Engineering has reviewed the plans for the Woodlands Landing at Echo Farms-Tract 3A project submitted February 1, 2019 and have the following comments:

WOODLANDS LANDING AT ECHO FARMS - TRACT 3A

DESIGN DOCUMENTS

C-5.1
 PEI JOB#: 18252.PE

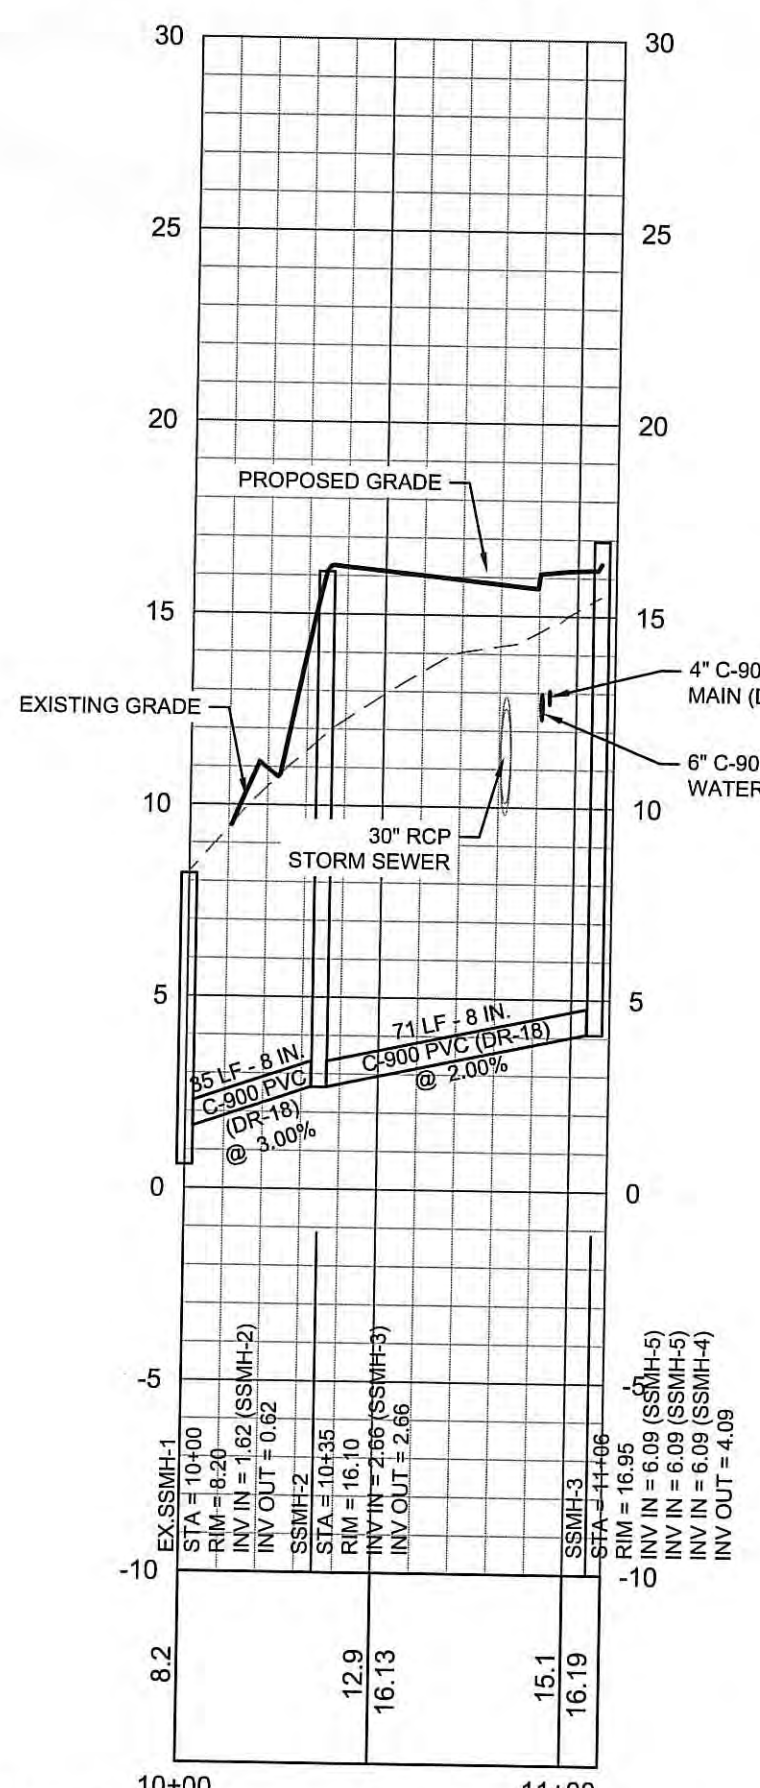
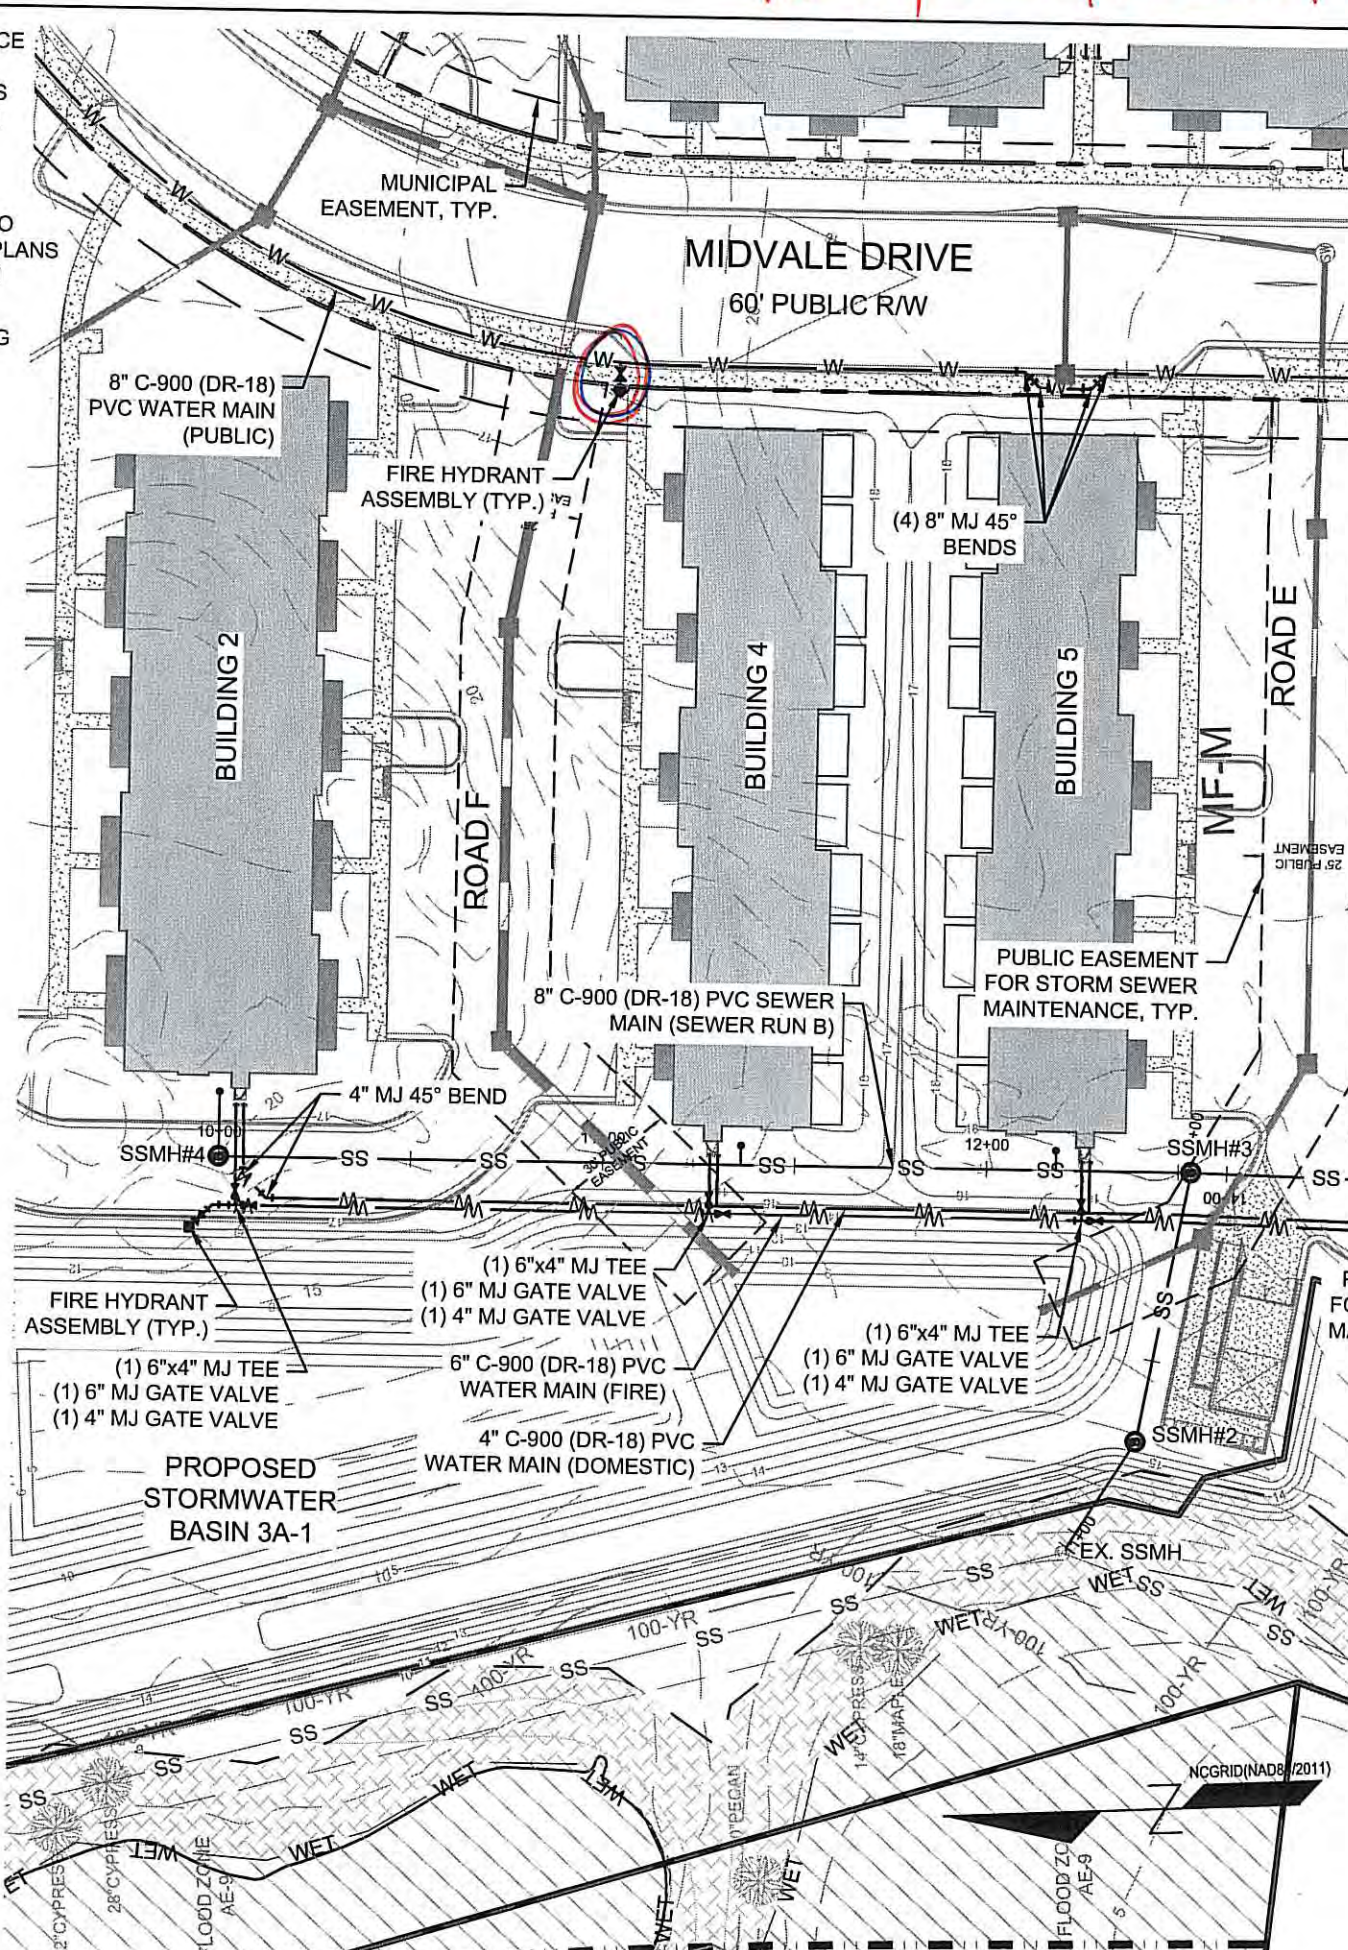
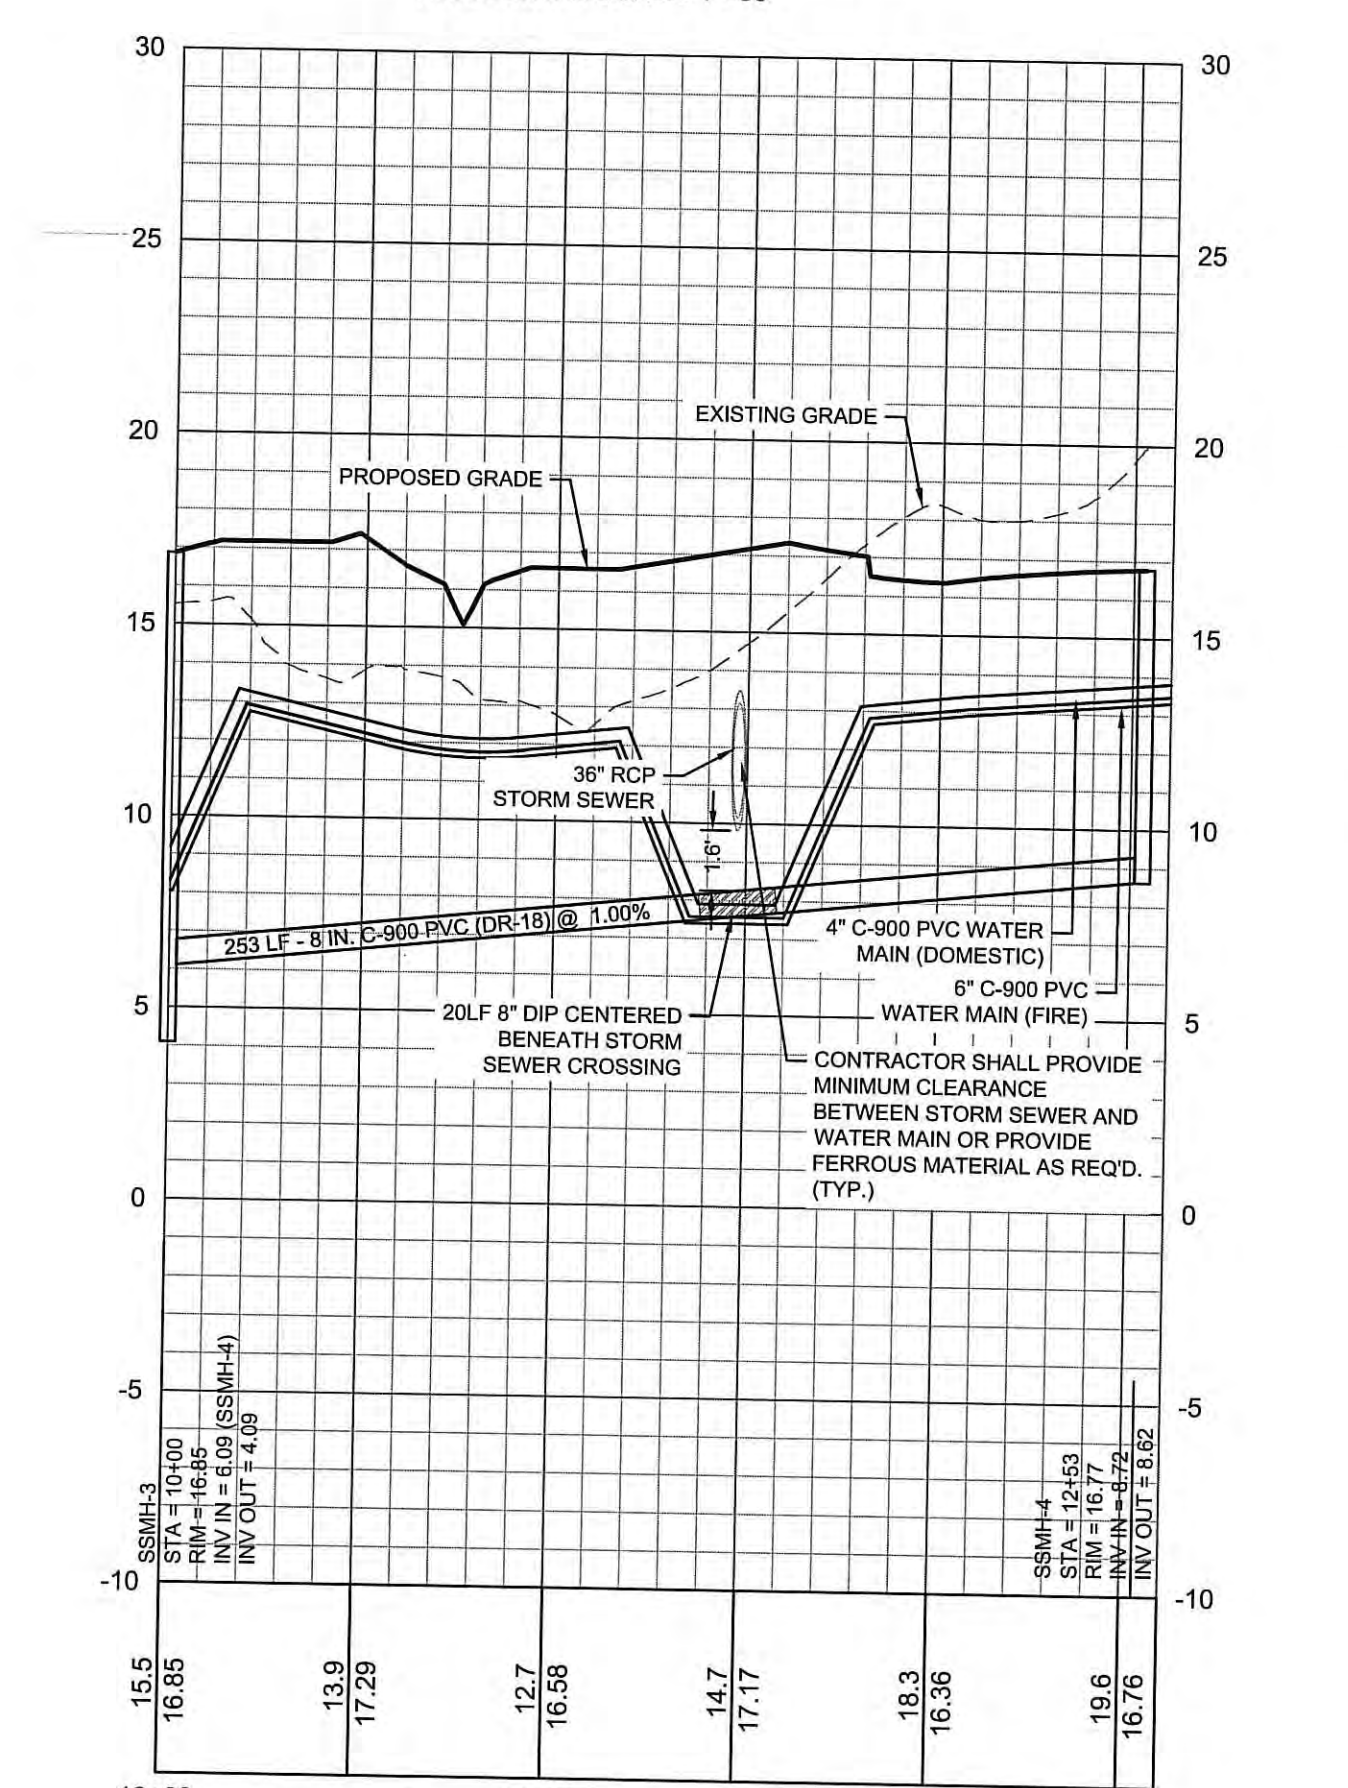
Valves, Fti's, cleanouts, etc. need to be kept outside of the sidewalk - setting/tripping hazard.
